## **CLARK, JR SUBDIVISION**

***Revised for the January 4<sup>th</sup> meeting:***

# DETAIL SITE PLAN

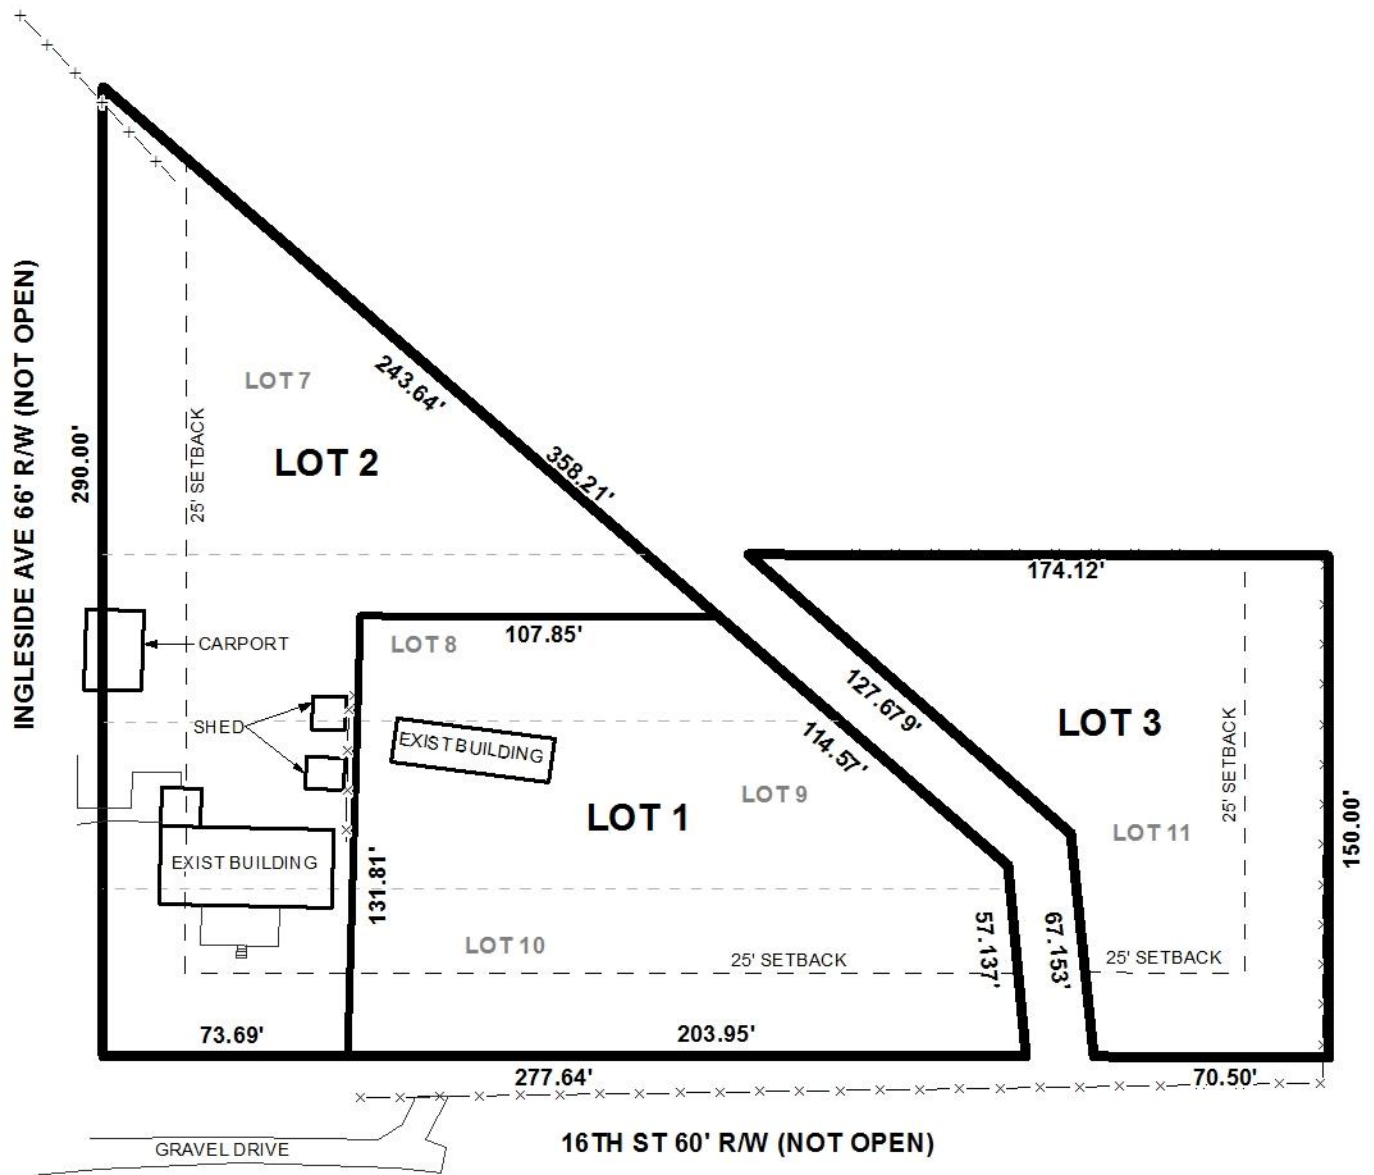
Section V.D.9. of the Subdivision Regulations requires the provision of a 25-foot minimum building setback from the "front property line". The preliminary plat does not depict the 25-foot minimum building setback line. The plat should be revised to depict the 25-foot minimum building setback lines for both Lots 1 and 2.

The preliminary plat depicts multiple existing structures on both the lots. Additionally, the proposed Lot 2 has an existing carport that is partially located in the unopened right-of-way and partially on private property. The carport structure should be relocated to be completely on private property.

It should also be pointed out that the preliminary plat is not consistent with the City's mapping and there appear to be some discrepancies amongst the two. The depiction of the alignment of the 12' wide ditch, the extension of the 20' alley, and Lot 11's access to the 20' alley appear to be in conflict.

*The applicant has since provided a revised preliminary plat that depicts 3 lots, the remaining portion of the parent parcel was combined to make one separate lot (Lot 3). Additional postage fees and labels were provided as well as the depiction of 25' minimum building setback lines for all proposed lots.*

*A note is also placed on the plat stating the carport that was partially in the right-of-way will be "removed from the public-right-of-way and relocated completely on private property". The plat was also revised to include the depiction of the location of the 12' wide ditch on the plat, the 20'*

*alley's full extension on the plat, and depiction of Lot 11's (currently proposed to be Lot 3) access to the 20' alley.*
